HISTORIC AND DESIGN REVIEW COMMISSION

HDRC CASE NO: 2019-343
ADDRESS: 414 DONALDSON AVE
LEGAL DESCRIPTION: NCB 1932 BLK 39 LOT 26 AND 27
ZONING: R-6,H
CITY COUNCIL DIST.: 7
DISTRICT: Monticello Park Historic District
APPLICANT: KKW Donaldson
OWNER: San Antonio San Antonio/KKW Donaldson
TYPE OF WORK: Window replacement, painting brick, replace siding
APPLICATION RECEIVED: May 22, 2019
60-DAY REVIEW: July 21, 2019
CASE MANAGER: Stephanie Phillips
REQUEST:

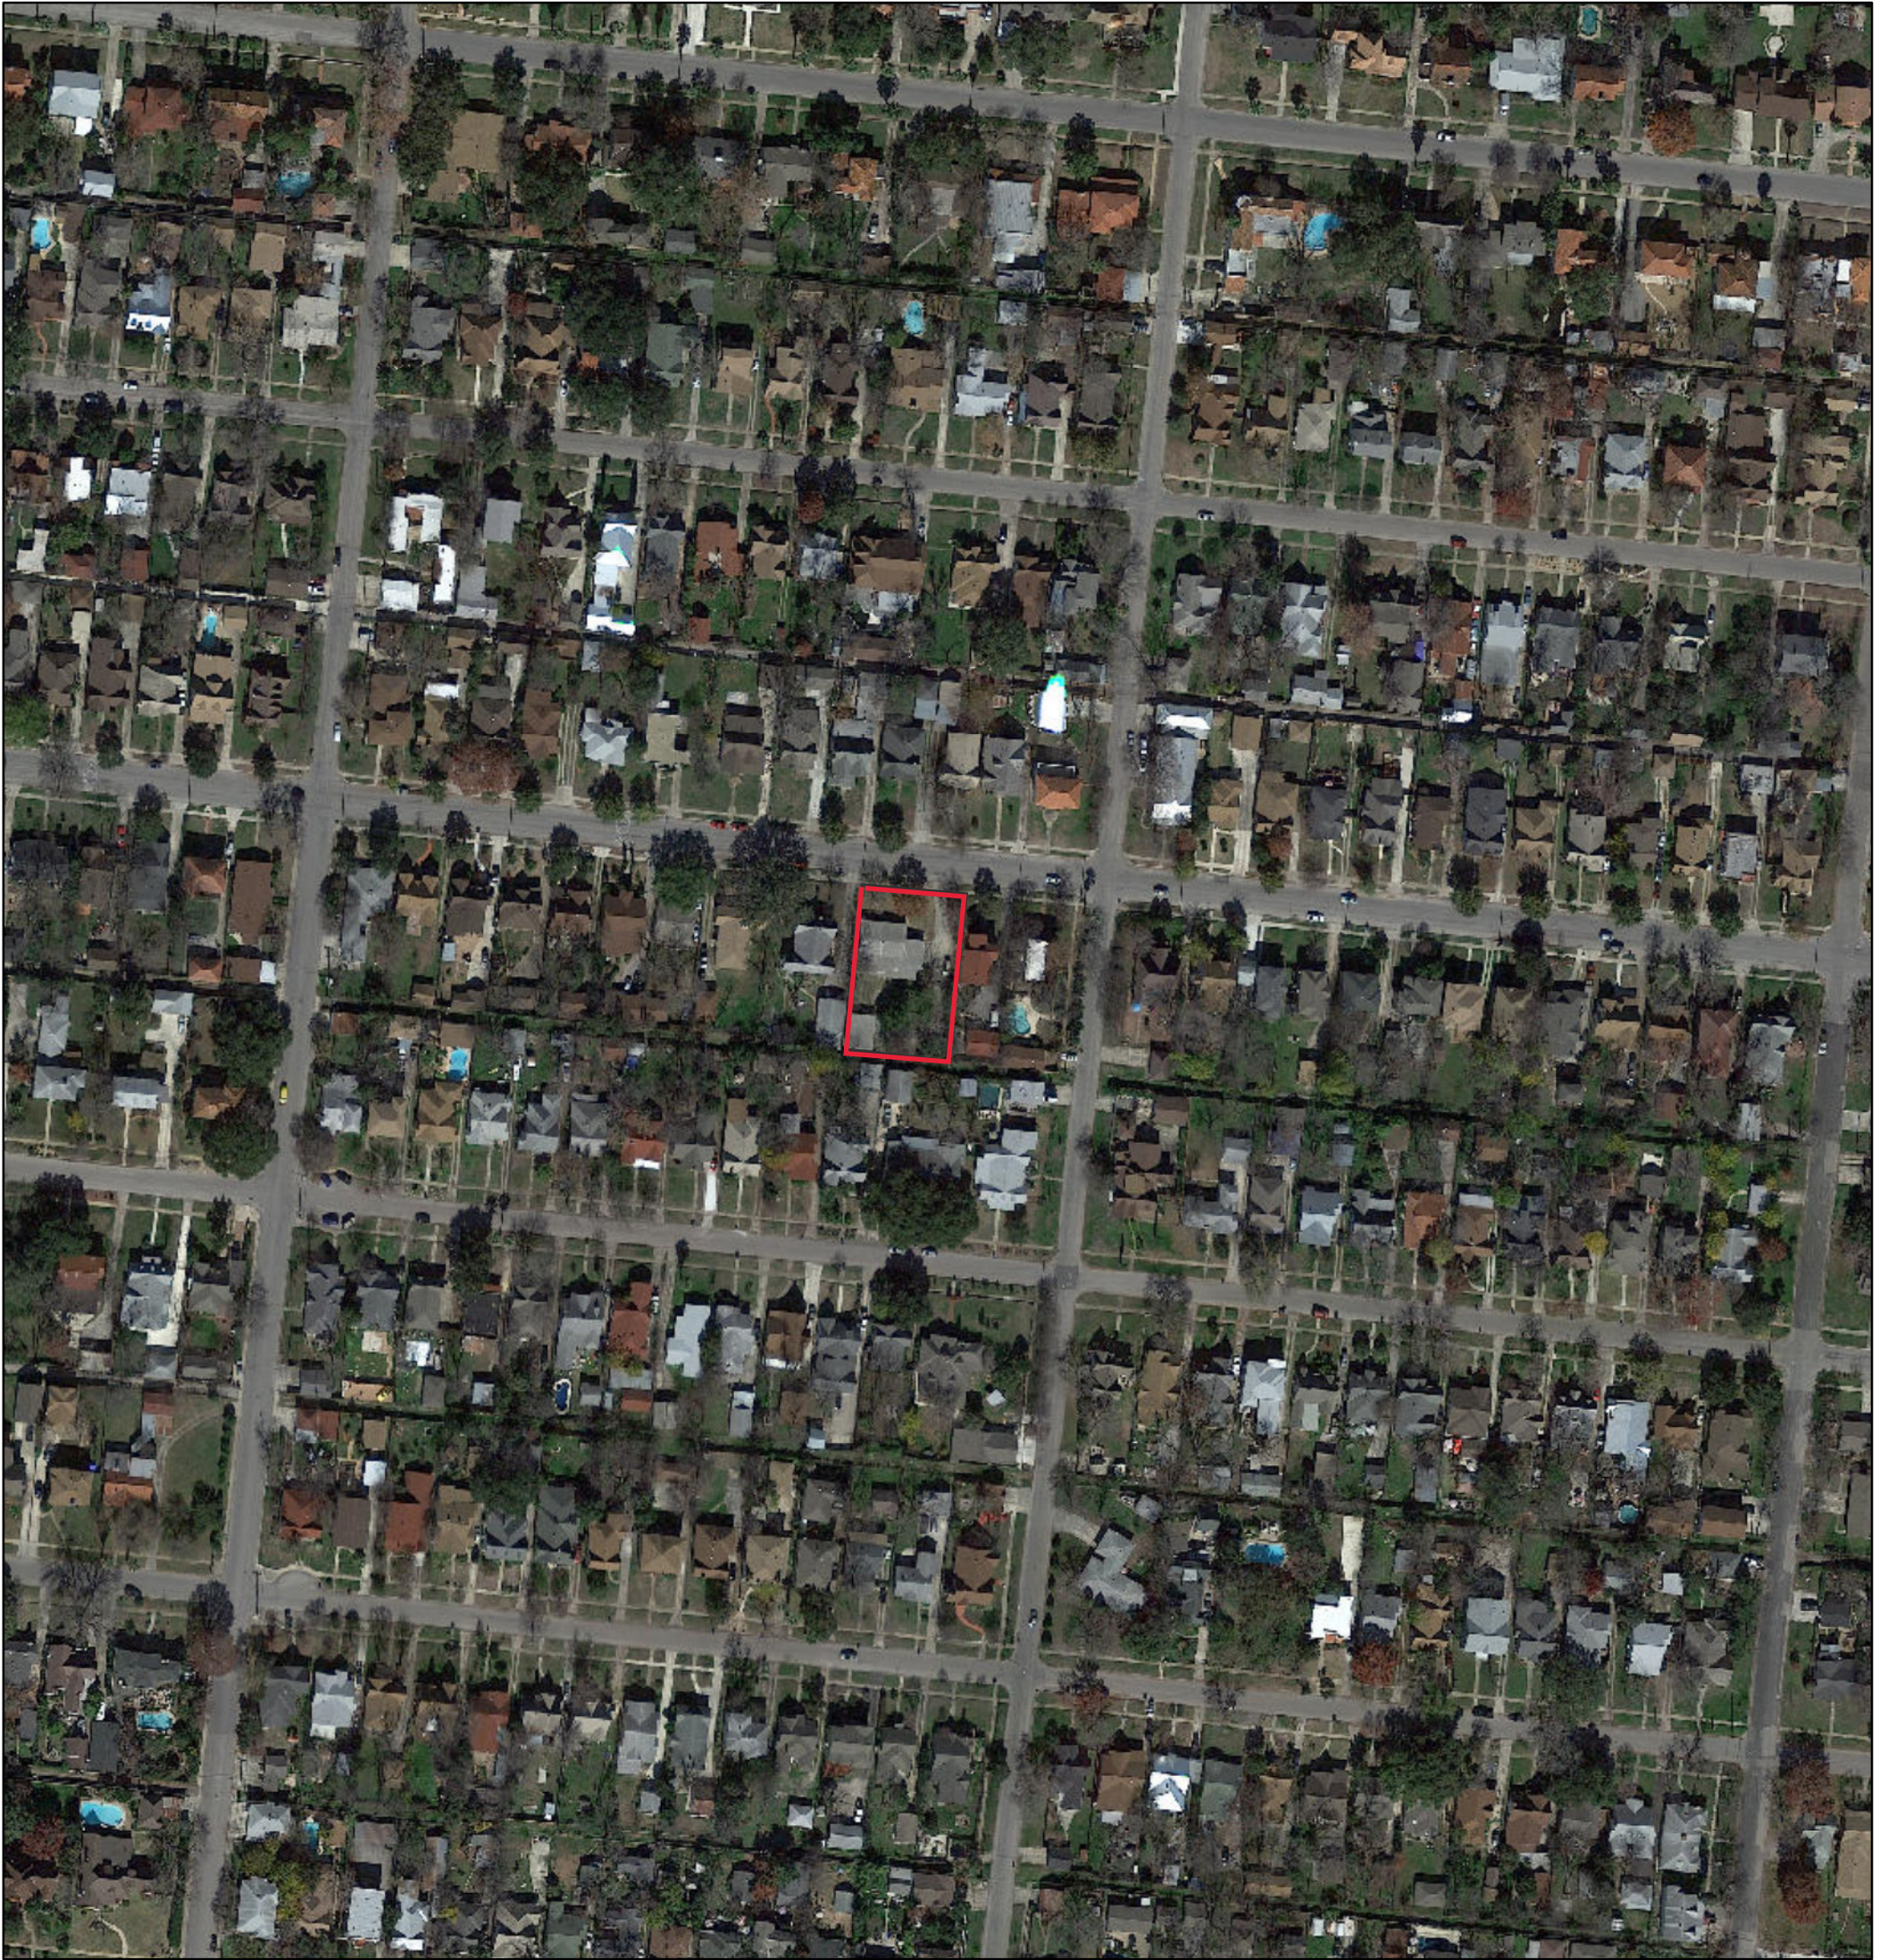
Item 3, Staff recommends approval of the window replacement based on finding d with the following stipulation:

- i. That the window size matches the existing opening and configuration. The applicant is required to submit an updated window specification to staff with dimensions for review and approval.
